T.I. no.: 2024-10 Updated: -	Topic: New combination sensor for closed drip tray
---------------------------------	--

Date: 29.07.2024	Priority and need for action <input type="checkbox"/> High: as soon as possible <input checked="" type="checkbox"/> Medium: on next visit to the machine <input type="checkbox"/> Low: FYI only
Affected machines: SKYE	
Up to serial number: 2418xxxxxx	
Start date: immediately

Figure 1: Combination sensor 100386 with Index C

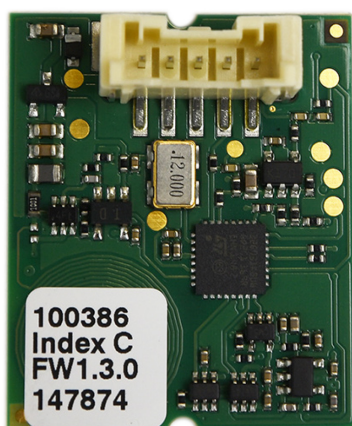
For the closed drip tray, a new calibrated combination sensor (100386 Index C) is available for optimising water level detection in the drip tray.

- If required, install the new 100386 Index C combination sensor for the closed SKYE drip tray **up to** serial number 2418xxxxxx.
